CITY OF ALBUQUERQUE

**RE: Blvd 2500
2500 Carlisle Blvd NE
Conceptual Grading & Drainage Plans
Engineer's Stamp Date: 01/30/23
Hydrology File: H17D002**

BLVD 2500
ALBUQUERQUE, NM
**CONCEPTUAL
GRADING & DRAINAGE PLAN**
TERRA WEST, LLC
5571 MIDWAY PARK PL. NE
ALBUQUERQUE, NEW MEXICO 87109
(505) 858-3100
www.tierrowestllc.com

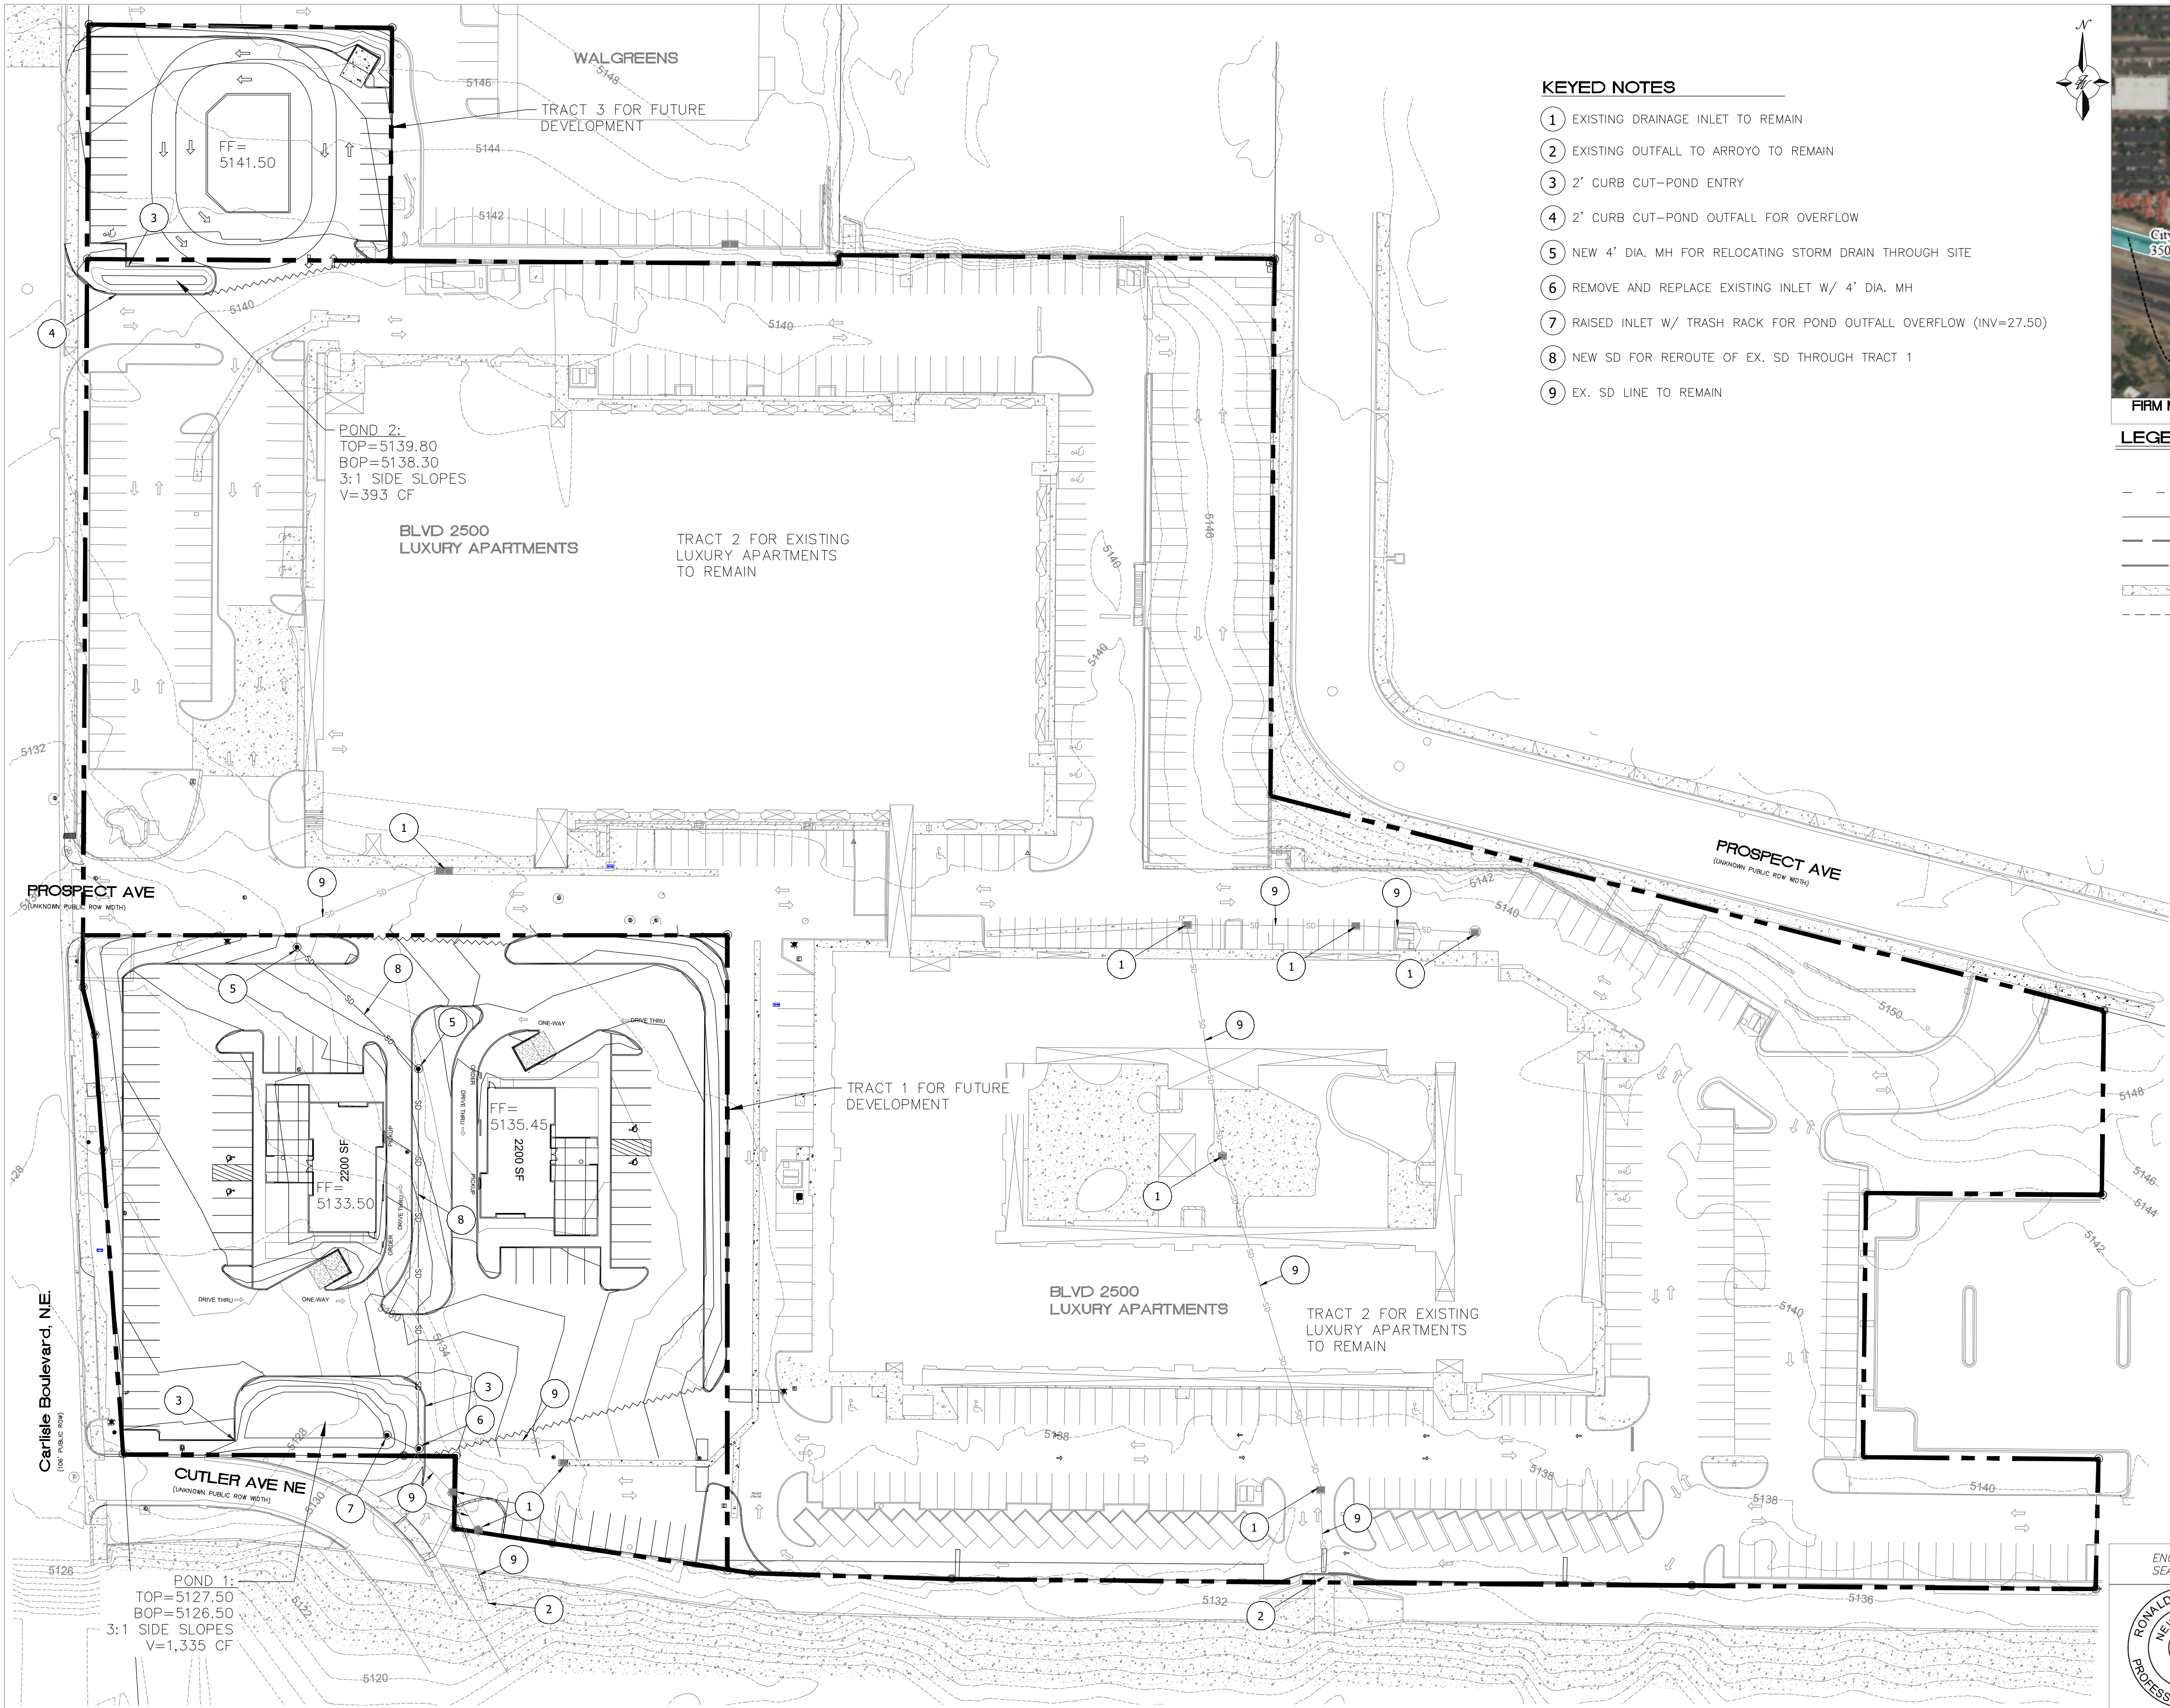
City of Albuquerque
Planning Department
Development Review Services
HYDROLOGY SECTION
PRELIMINARY APPROVED
DATE: 02/01/23
BY: *Ronald R. Bohannon*
HydroTrans # H17D002
THESE PLANS AND/OR REPORT ARE
CONCEPTUAL ONLY. MORE INFORMATION MAY
BE NEEDED IN THEM AND SUBMITTED TO
HYDROLOGY FOR BUILDING PERMIT APPROVAL.
